**BEFORE THE BOARD OF ZONING ADJUSTMENT
FOR THE DISTRICT OF COLUMBIA**

APPEAL OF A DECISION OF THE ZONING ADMINISTRATOR FOR THE DISTRICT OF
COLUMBIA, DEPARTMENT OF CONSUMER AND REGULATORY AFFAIRS
SUBDIVISION OF LOT 108 ON SQUARE 192

**REPLY STATEMENT OF
PROFESSOR JAMES MCCRERY IN
SUPPORT OF APPEAL OF ZONING ADMINISTRATOR'S
APPROVAL OF SUBDIVISION OF SQUARE 192 LOT 108**

Figure 1

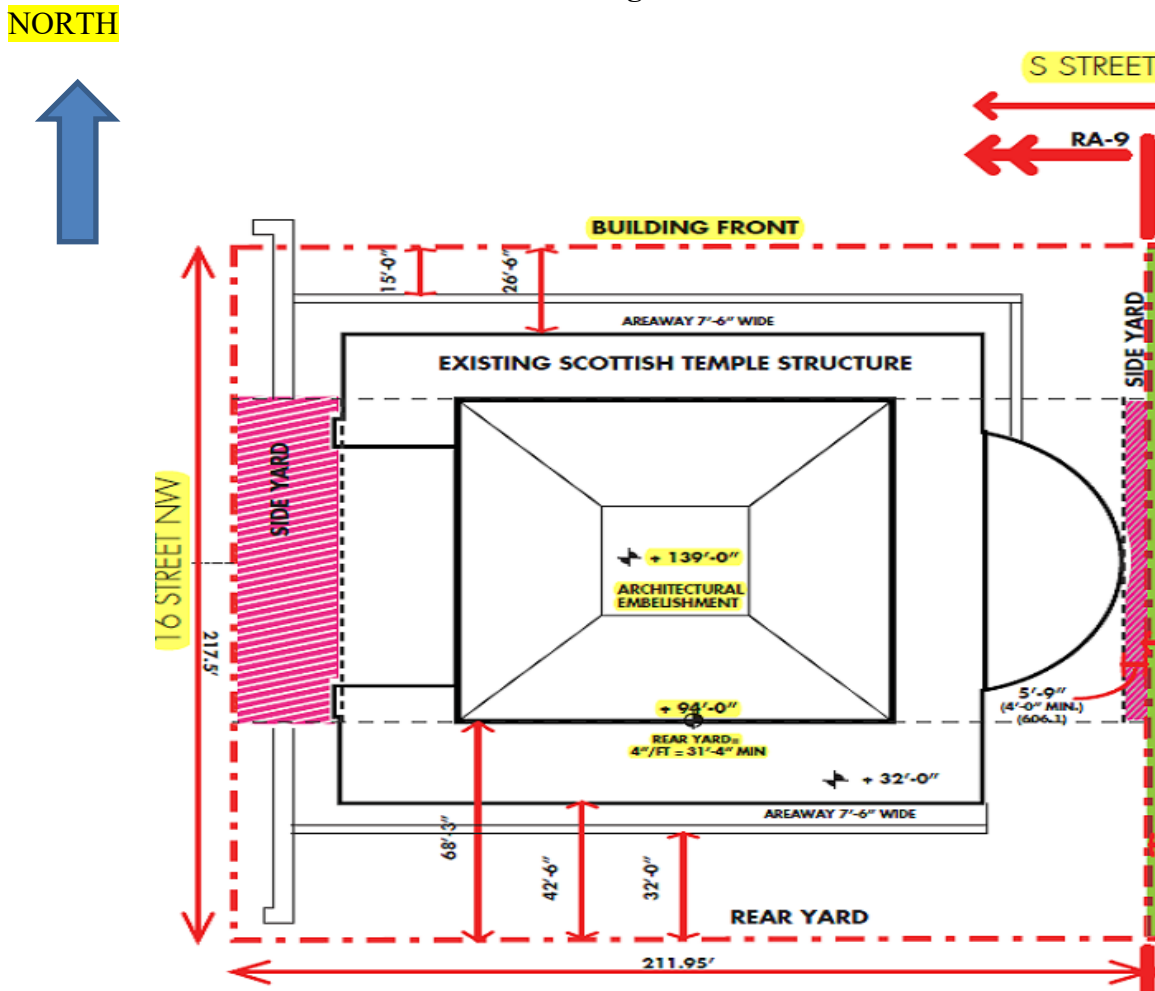
As established by Figure 1 below (from Perseus Application Package) (available at https://drive.google.com/file/d/1i9xXfj_g4IPLbwrPwJ2oiBmvkZtpC4qc/view?usp=sharing), the height of the Temple is 139' (not including the depth of the areaway). Thus, to comply with 11-F DCMR § 605.1, the width of the rear yard must be:

However, as established by Perseus own calculations, the rear yard is only 42'6" wide, including the areaway:

Figure 7 (Perseus Ex. B)

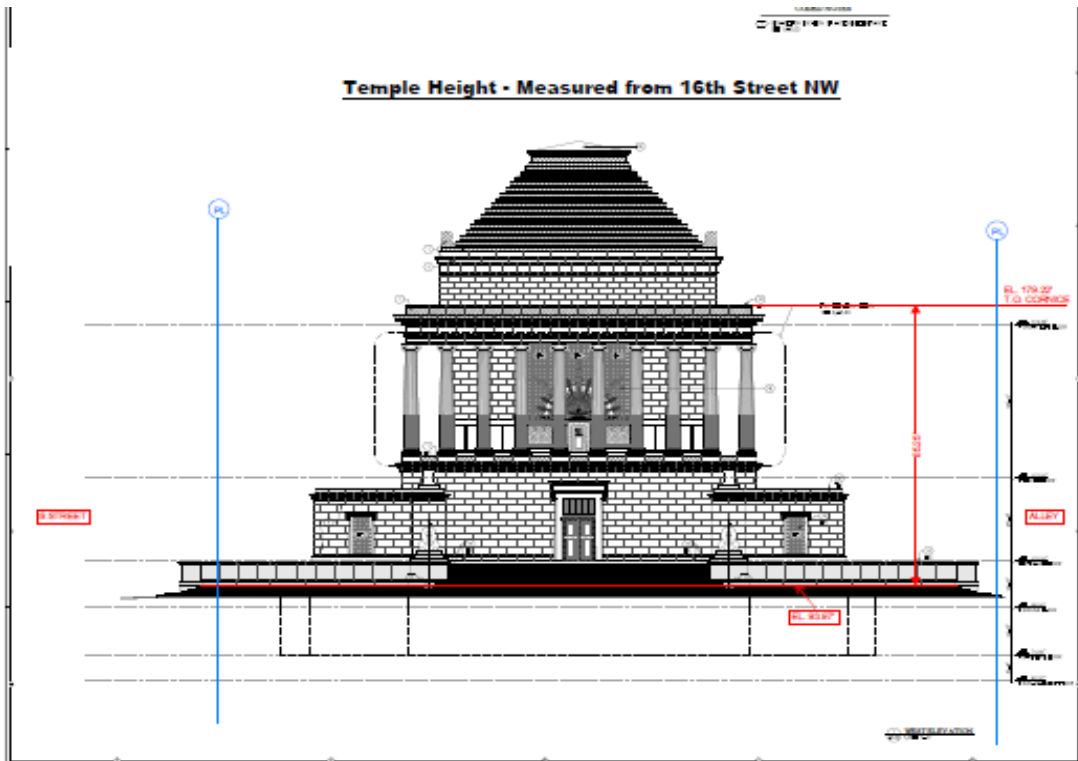
Perseus first attempts to chip away at the Temple's legitimate height by offering another height calculation for the Temple height from 16th Street, claiming (contrary to their previous submission to the HPRB) that the Temple's height is 134'6” from this perspective. *See* Perseus Opp. Exhibit C. To reach this calculation, Perseus does not measure from the sidewalk, as required (assuming for these purposes that 16th Street is the proper location from which to take the measurement, which it is not, if the rear yard is to the south of the Temple), but instead begins its measurement approximately 5' higher up the stairs at the front of the building. *See* Perseus Opp. Ex. B. This is an inaccurate measurement. 11-B DCMR § 308.2 states as follows:

It is obvious from Exhibit B that the 134'6" measurement is not being taken from the sidewalk, but artificially measured from a higher point at the top of the first set of stairs for the sole purpose of attempting to reduce the Temple's height.

Comparing this diagram to the picture below (Figure 3) showing the front of the Temple establishes that Perseus is not measuring the height from the sidewalk.

Figure 9

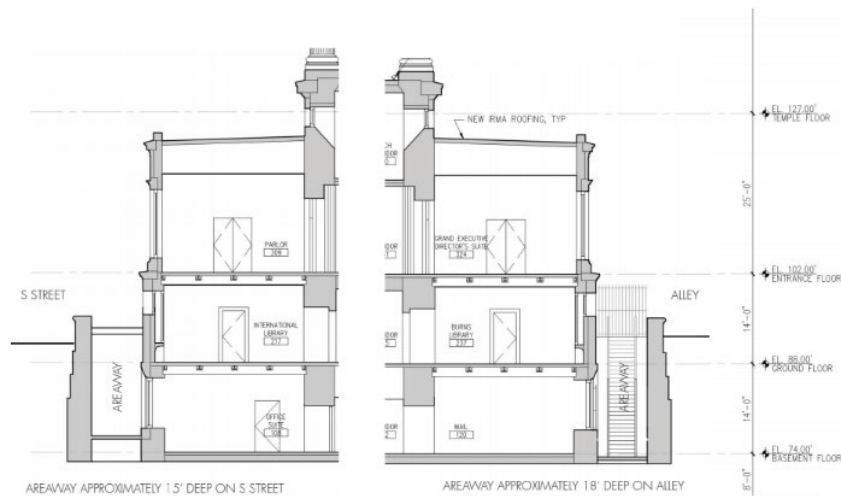
Per Figure 9 below prepared by the developer, the areaway at the redesignated “front” of the Temple on S Street is 15 feet deep:

Thus, 15 feet must be added to the Temple’s height (139’) for a total height of 154’. Multiplying that number by 1/3 reveals that that minimum width of the rear yard must be at least 51’4”.

The District's contention that the 15' depth of the areaway is excluded from the BMPH calculation because it is an exception to grade is misguided. It cites the regulation that provides an exception to grade for an areaway, but ignores that the exception applies only to an areaway that "projects no more than five feet (5 ft) from the building fact. 11-B DCMR § 100.1. It does not dispute that the areaway here, according to Perseus' own measurements, extends 7'6" from the Temple's face. Thus, the areaway is included in the BMPH calculation.

Figure 11

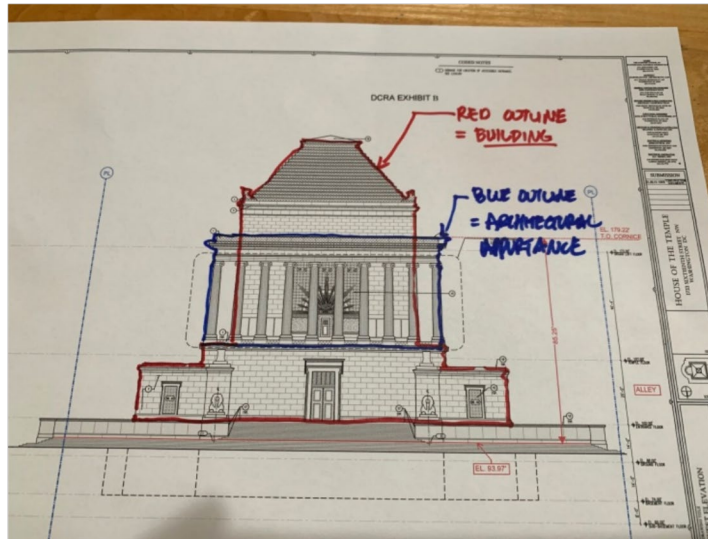
As previously noted, 11-C DCMR § 1501.3 expressly provides that a dome *cannot* be deemed an “embellishment” if it results “in the appearance of a raised building height for more than thirty percent (30%) of the wall on which the architectural embellishment is located.” Here, the Temple's pyramidal roof, which is co-extensive with the walls of the Temple, obviously gives “the appearance of a raised building height for more than thirty percent (30%) of the wall” on which it sits. Below is a diagram of the Temple, with the building's structure outlined:

Thus, the Temple’s roof sits upon all the walls of the Temple, and thus cannot satisfy the requirements to be deemed an “architectural embellishment.”

The Oppositions make two wholly misguided assertions in an attempt to avoid the exclusionary provisions of 11-C DCMR § 1501.3. *First*, both the District and Perseus claim that “the dome is not located on a wall.” District Opp. 7; Perseus Opp. 13. This assertion is clearly wrong, as the diagram above shows.

Figure 15

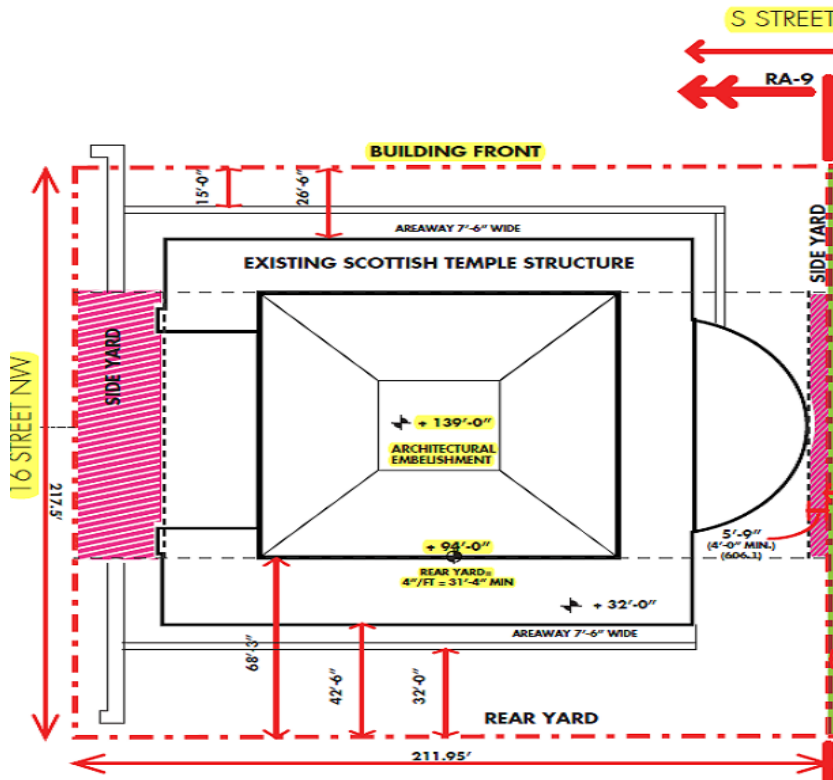
Here, the structure and accompanying wall identified in the below pictures occupying a portion of the Redesignated Rear Yard violates these provisions. They are 11’6” tall.

That structure and wall, as evidenced by the below diagram Perseus prepared, are clearly in the “rear yard” as designated now by Perseus.
